TRIM—REAR COAT HOOK/LAMP LOOSE IN HEADLINER	Article No. 03-1-2

FORD: 1999-2003 WINDSTAR

Figure 1 - Article 03-1-2

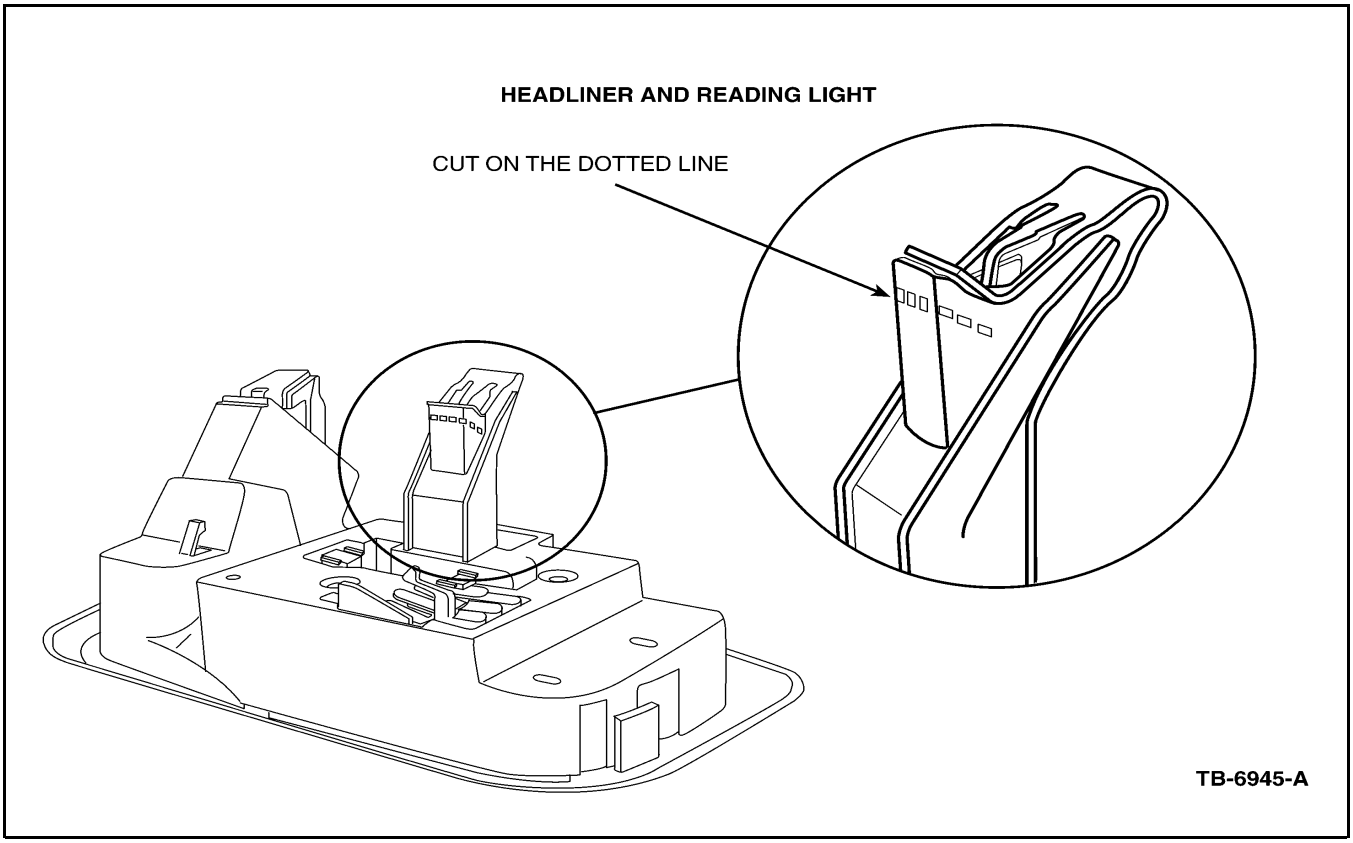
Some vehicles may exhibit a rear coat hook/reading lamp not secured properly in the headliner. This may be caused by the attachment procedure used.

1. Remove the reading lamp from the headliner and unplug the wire connector.
2. Remove the clip from the back side of the lamp.
3. Measure 2-3 mm from the edge of clip support (along dotted line shown in Figure 1).
4. Cut/remove the 2-3 mm of material (as per dotted line in Figure 1). This will allow the clip to travel further down tab, and once engaged in sheet metal the gap will be reduced.
5. Reinstall the clip on the back of the lamp.
6. Reinstall the connector on the lamp and reinstall the lamp into the headliner. Make sure that it is flush against the headliner.
